ADDENDUM

NO. 1

PROJECT NAME: Tomball ISD Intermediate School Replacement

ADDENDUM DATE: Tuesday, July 28, 2026

1 ENLARGED PLAN - LEARNING STAIR - LEVEL 1
1/4" = 1'-0" BACK REF: A1.1C

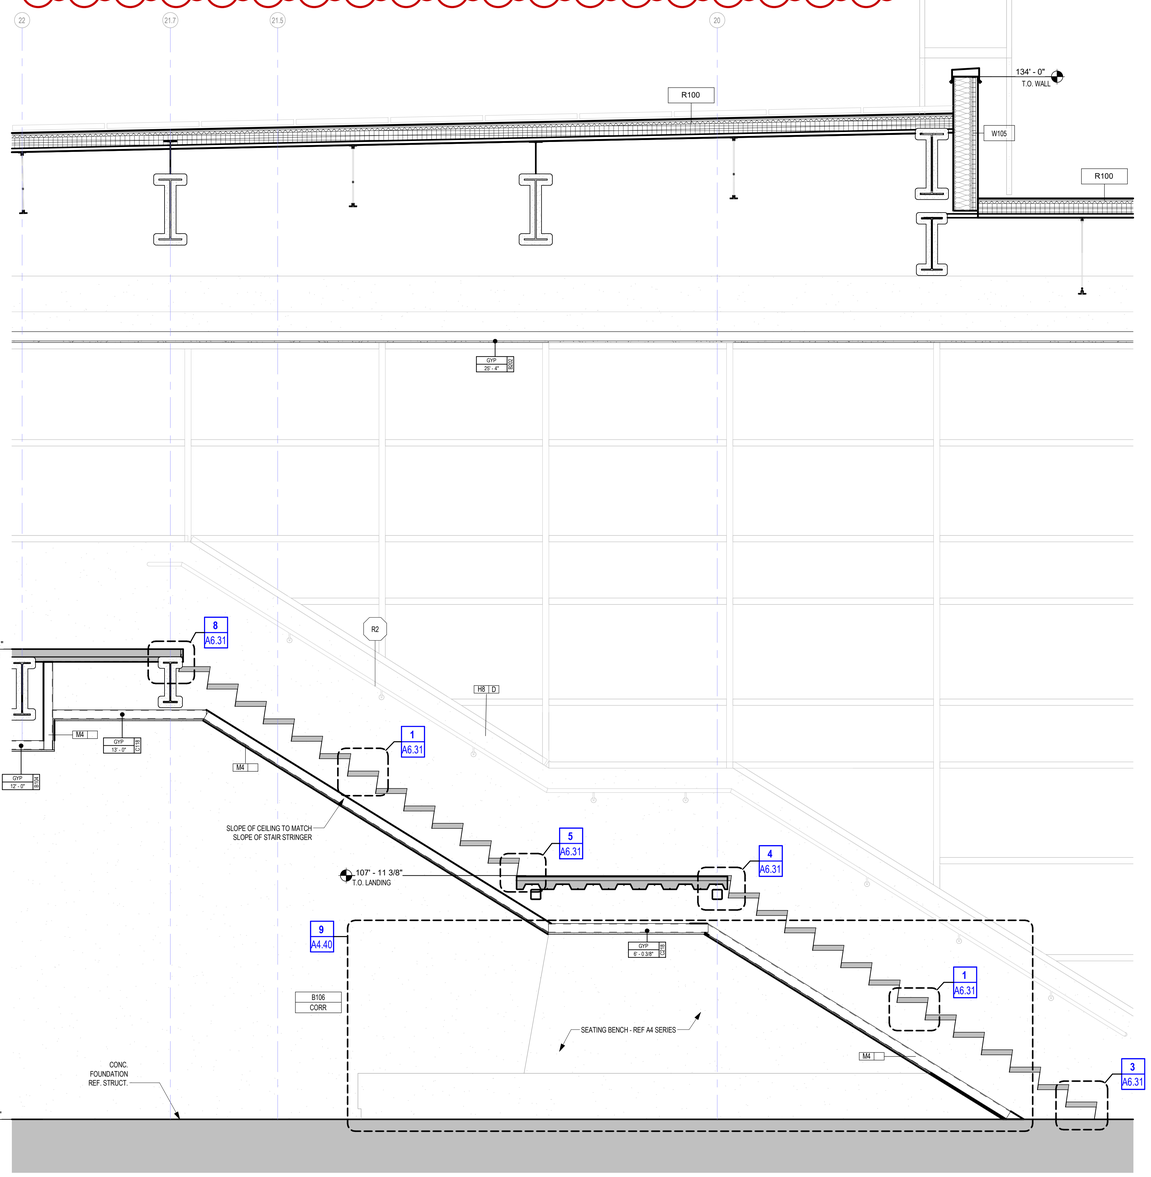
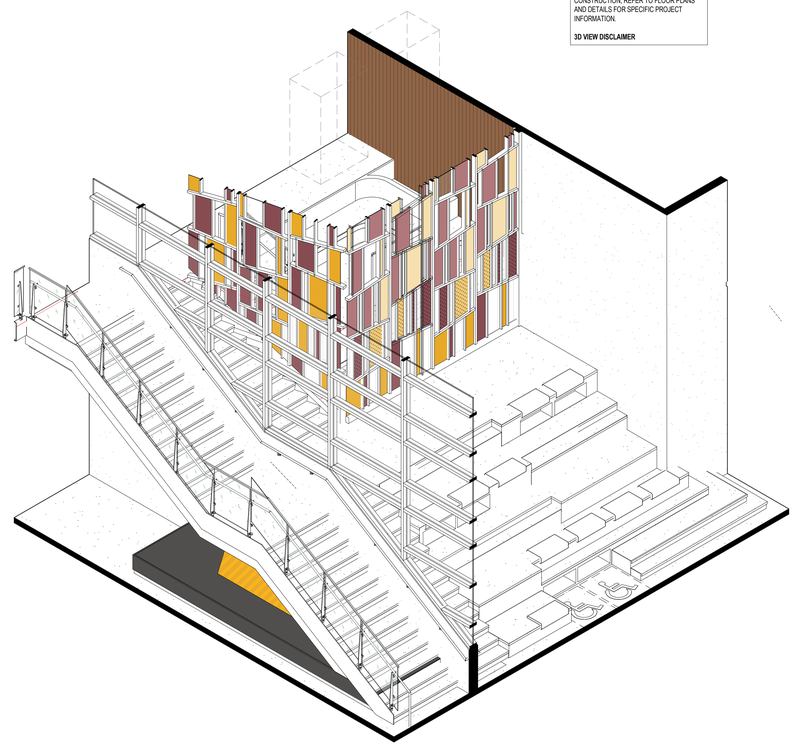
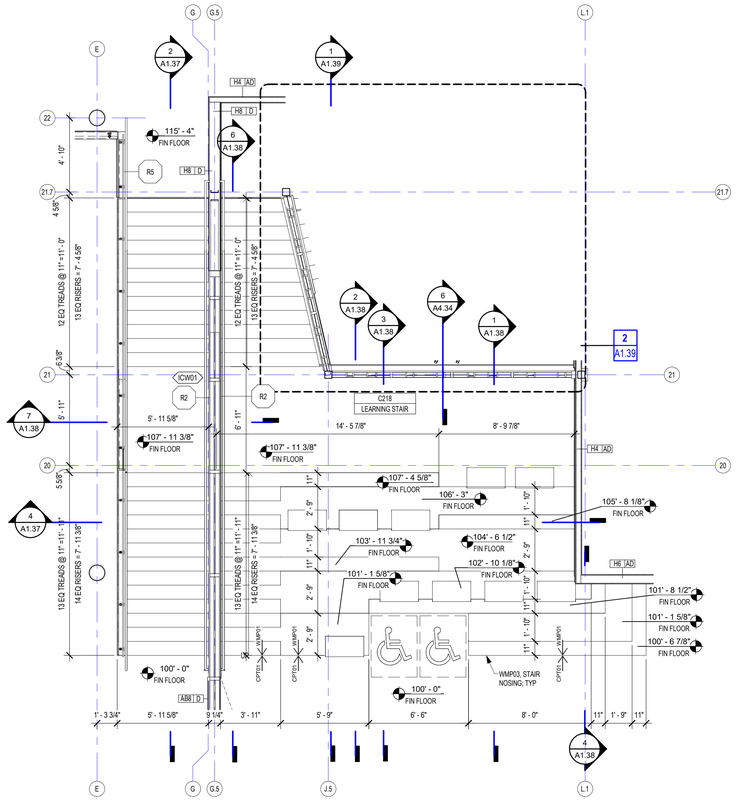
AD No 1, Arch. Item 4: **To the Drawings, Sheet A1.37,"LEARNING STAIRS"**
Added view 4/A1.37.

1 MASTER REFLECTED CEILING PLAN - LEVEL 01
1" = 20'-0"

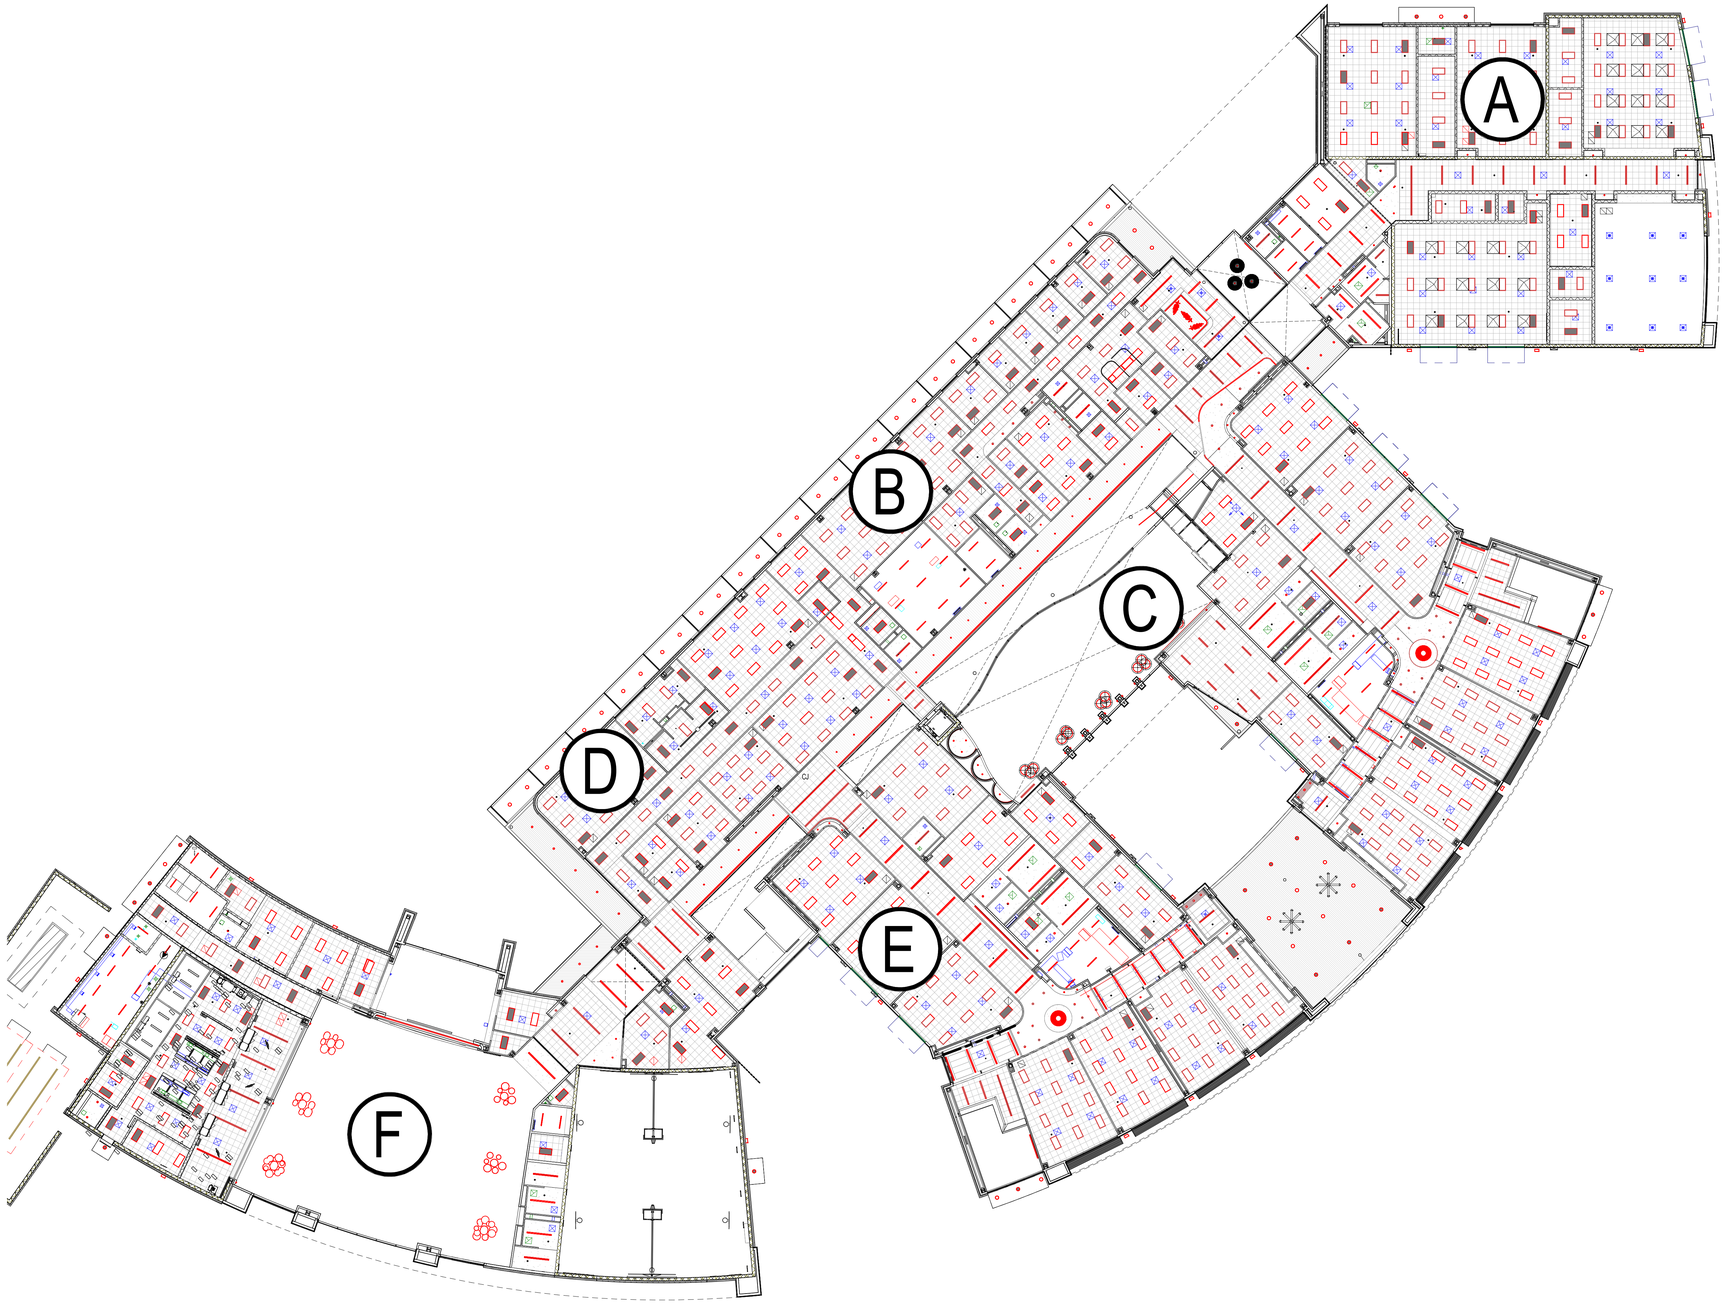
AD No 1, Arch. Item 8: **To the Drawings, Sheet A2.01,"MASTER REFLECTED CEILING PLAN – LEVEL 01"**
Added general note #6.

1 FINISH PLAN - LEVEL 02 - AREA B
1/8" = 1'-0"

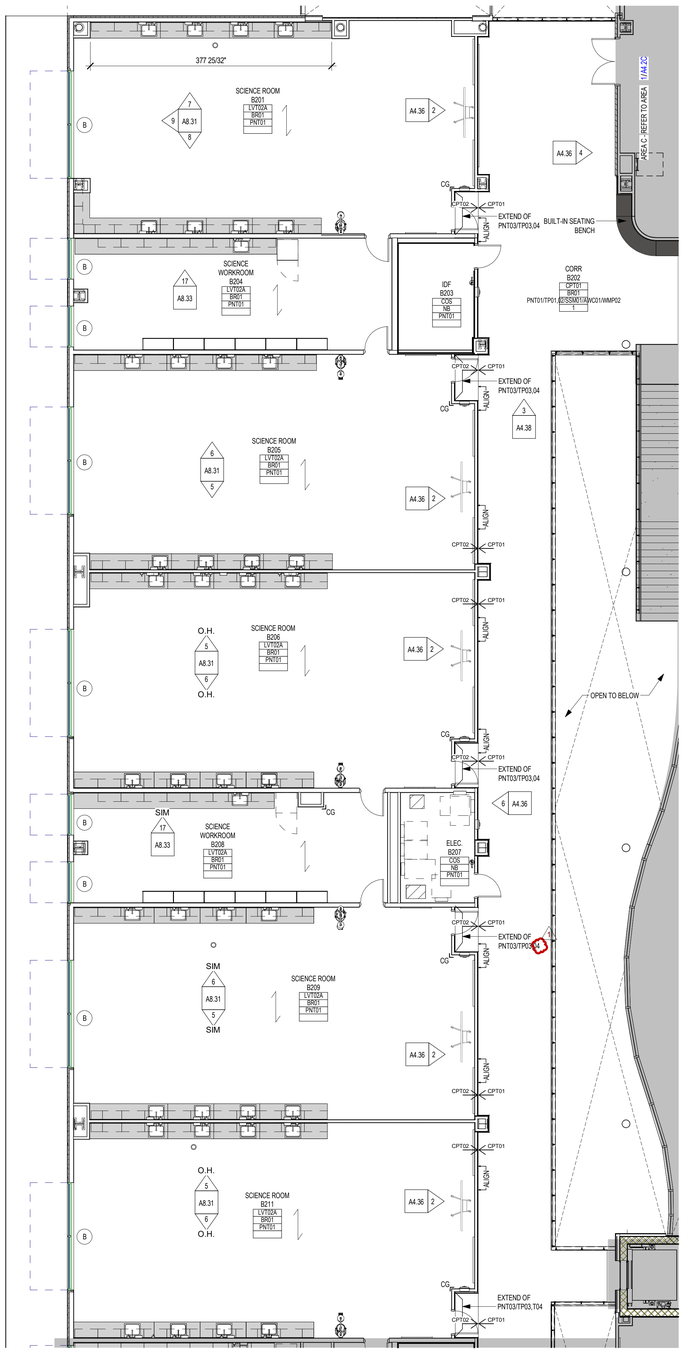
AD No 1, Arch. Item 12: **To the Drawings, Sheet A4.2B,"FINISH PLAN – LEVEL 2- AREA B"**
Revised tile annotation at alcoves. typical throughout project.
Revised FINISH PLAN GENERAL NOTES #10.

1 EQUIPMENT PLAN - LEVEL 02 - AREA B
1/8" = 1'-0"

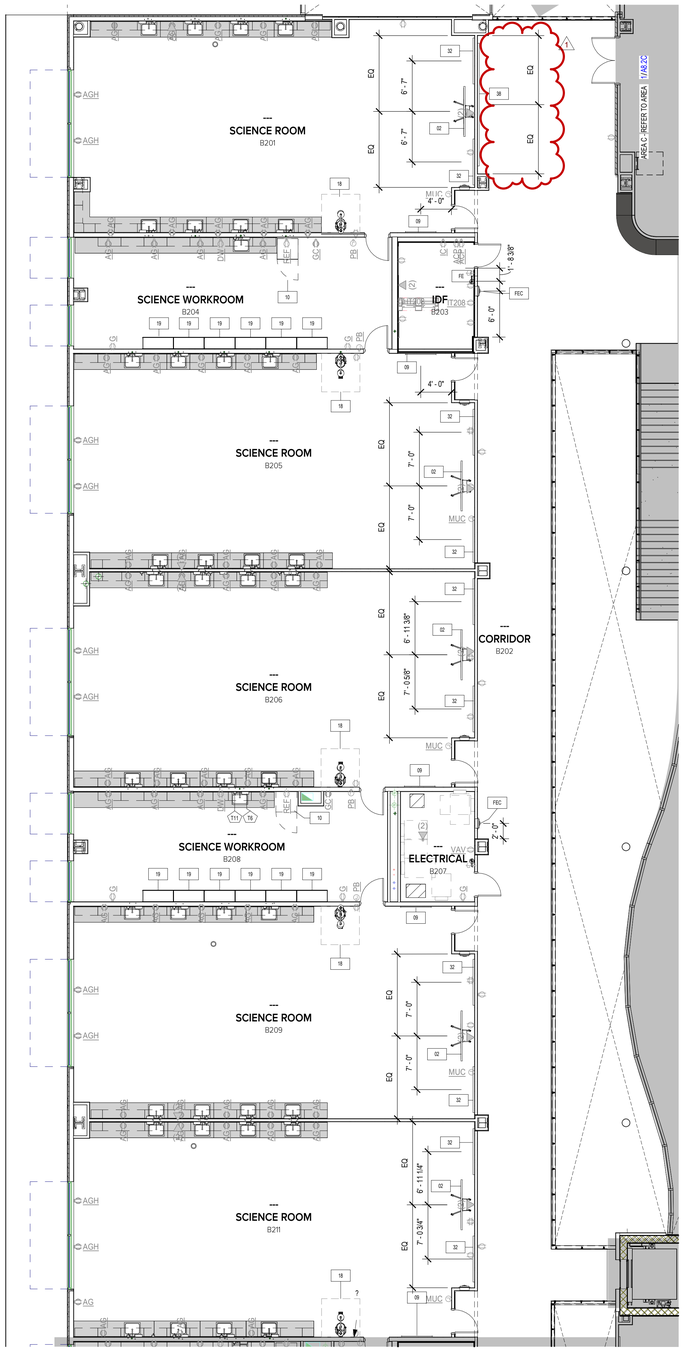
AD No 1, Arch. Item 19: **To the Drawings, Sheet A8.2B,"SIGNAGE AND EQUIPMENT PLAN – LEVEL 02 – AREA B"**
Added equipment item #38 to the equipment schedule and the plan.

1 PLUMBING PLAN - BELOW SLAB - AREA B
1/8" = 1'-0"

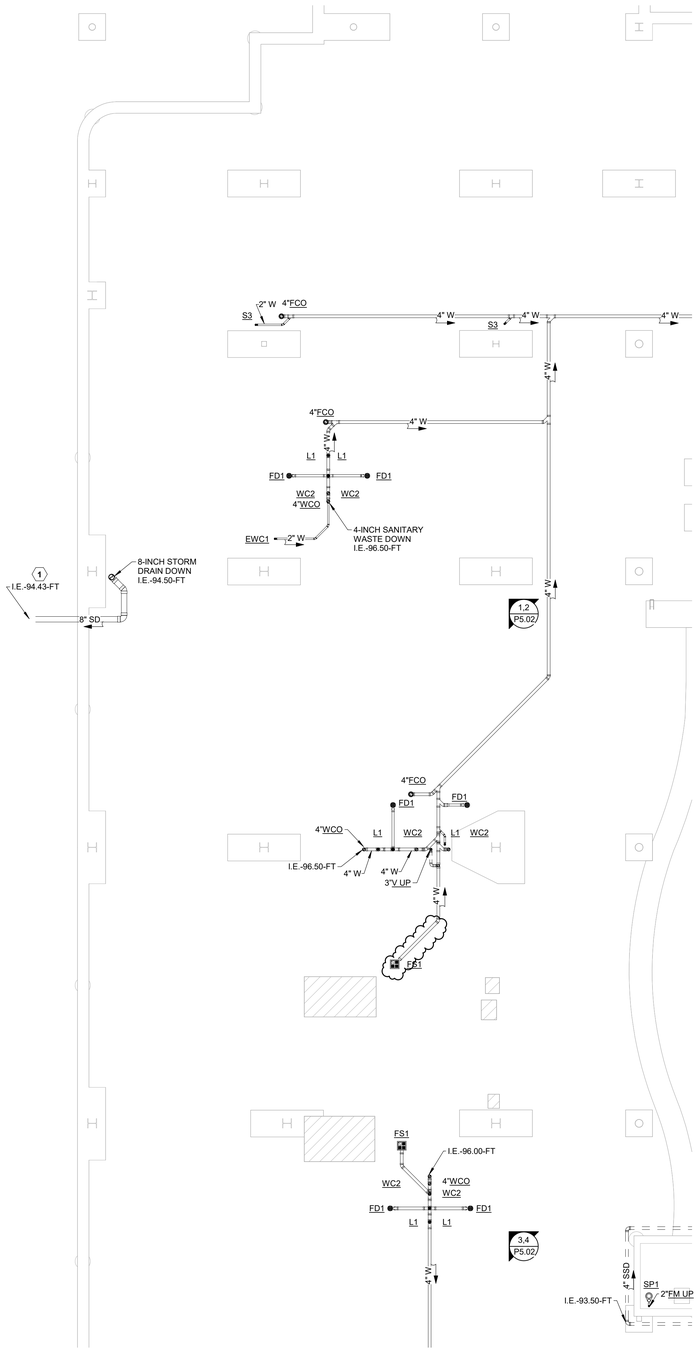
AD No 1, Plumb. Item 2: To the Drawings, Sheet P2.0B,"PLUMBING PLAN – UNDER SLAB – AREA B"

1 PLUMBING PLAN - BELOW SLAB - AREA C
1/8" = 1'-0"

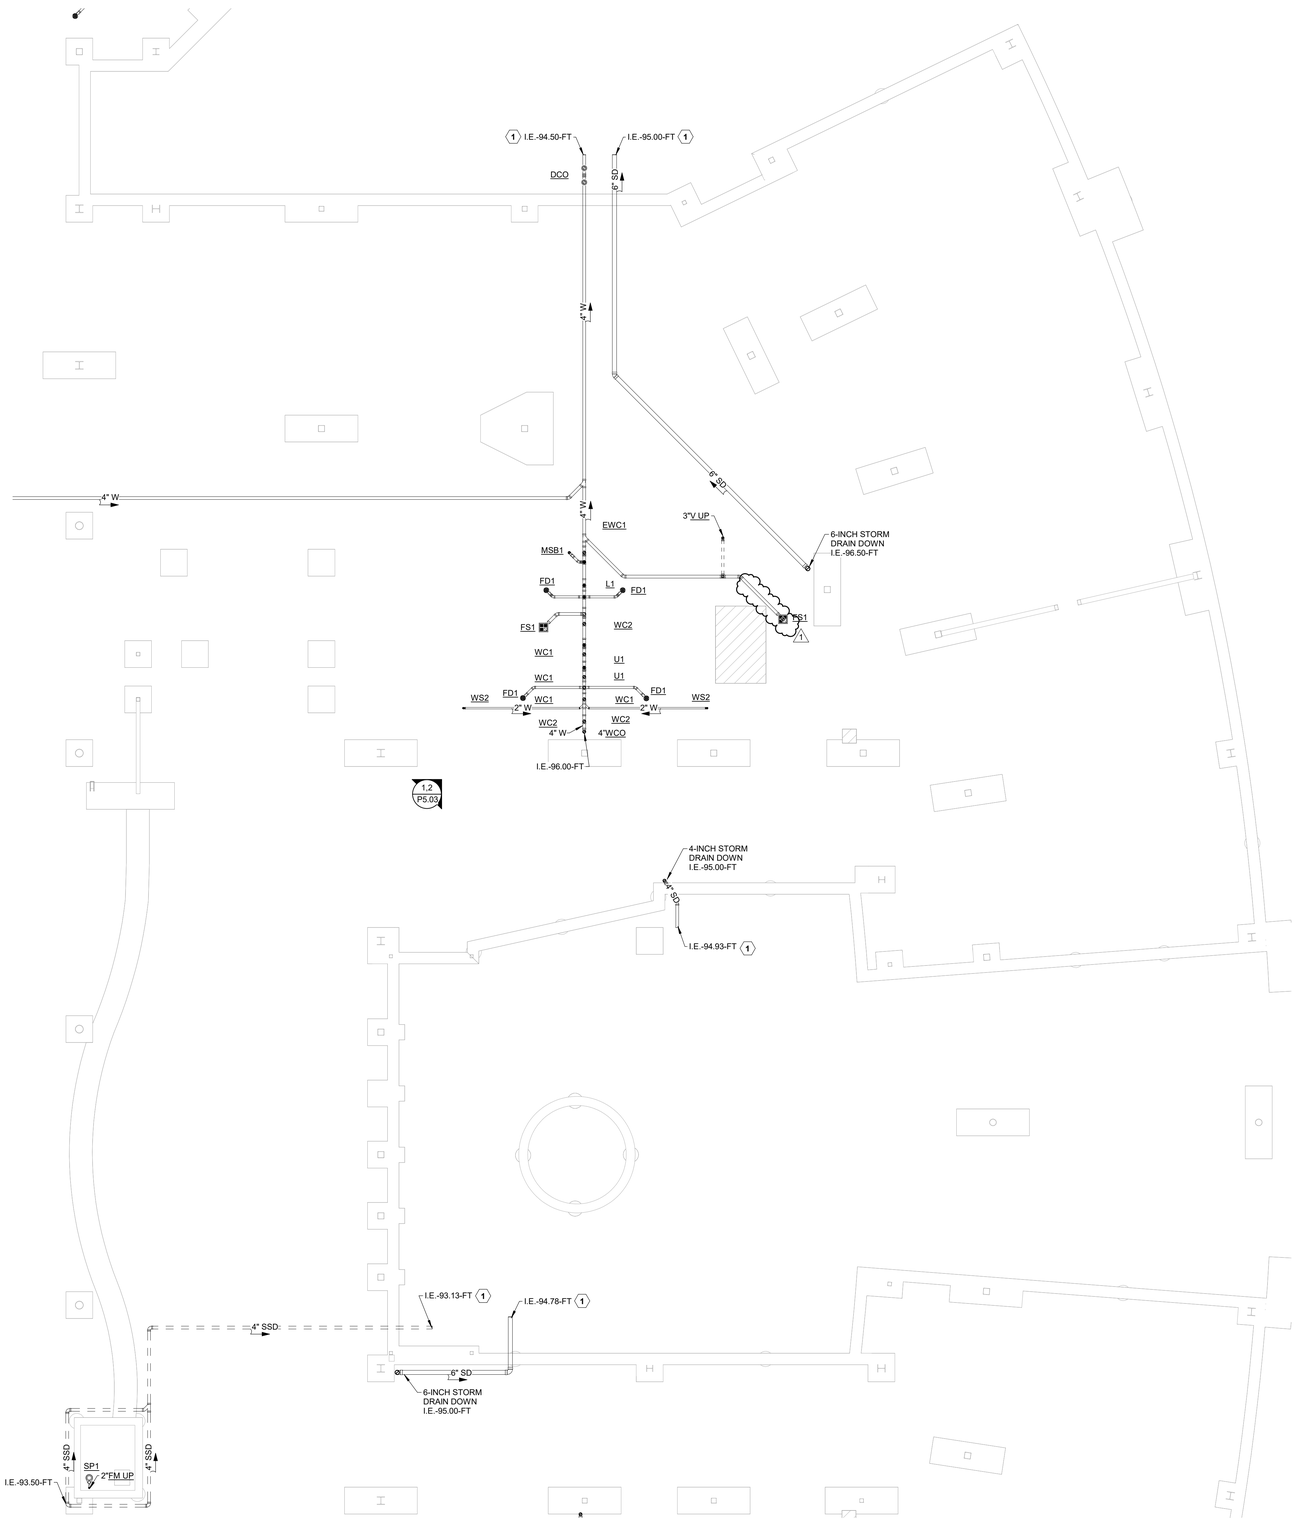
AD No 1, Plumb. Item 3: To the Drawings, Sheet P2.0C,"PLUMBING PLAN – UNDER SLAB – AREA C"

1 PLUMBING PLAN - BELOW SLAB - AREA E
1/8" = 1'-0"

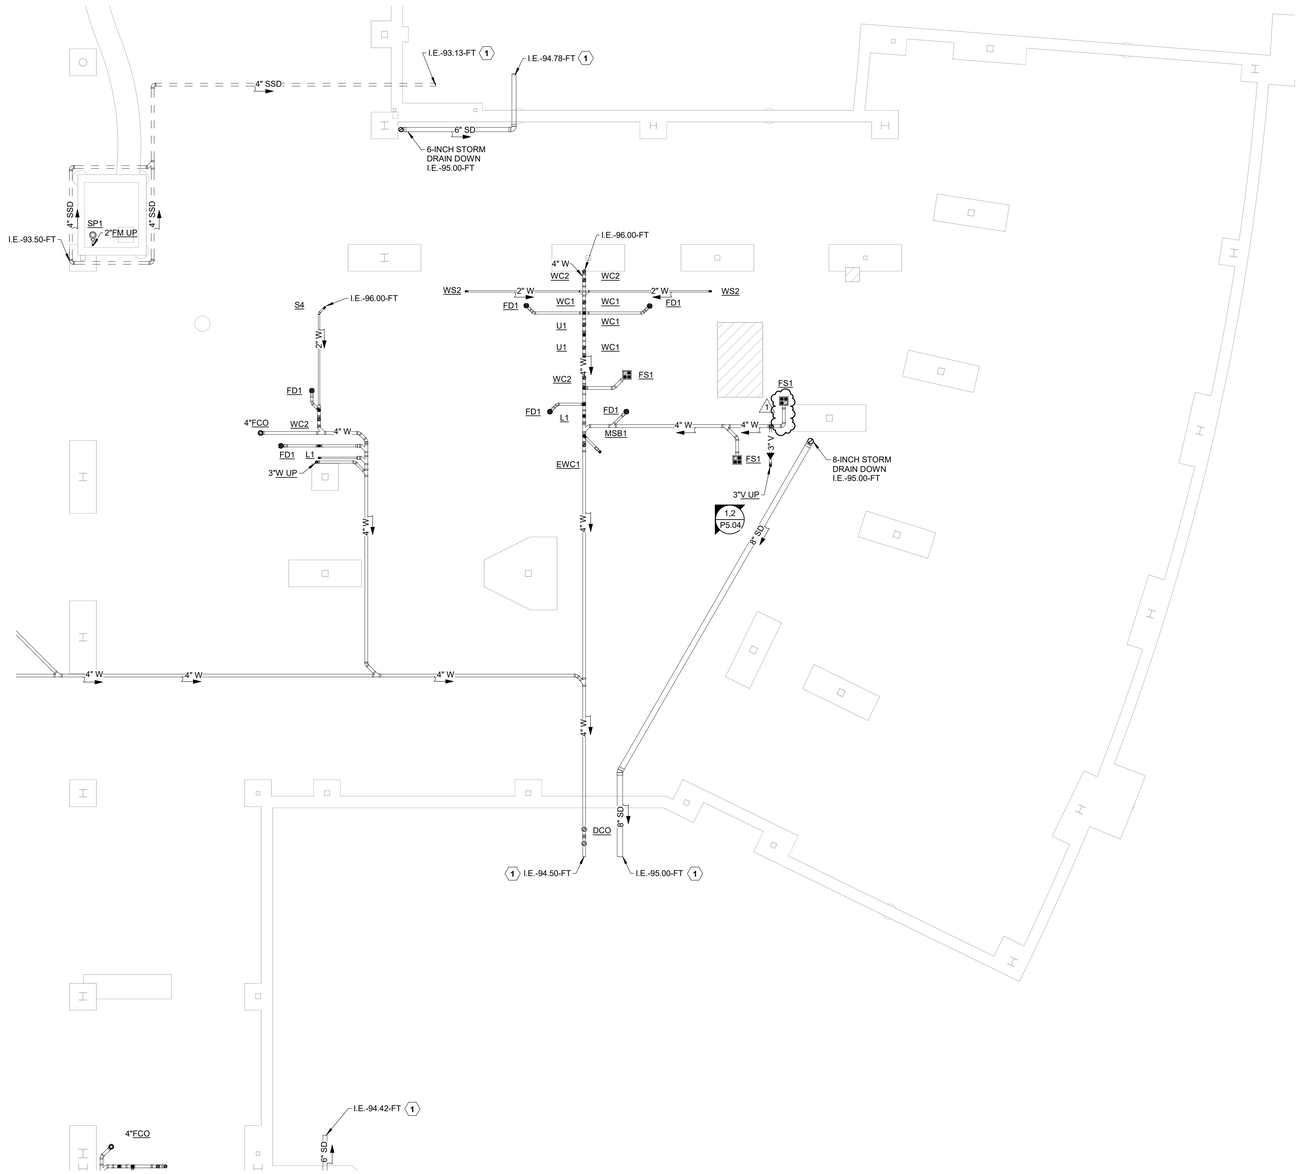
AD No 1, Plumb. Item 4: To the Drawings, Sheet P2.0E,"PLUMBING PLAN – UNDER SLAB – AREA E"
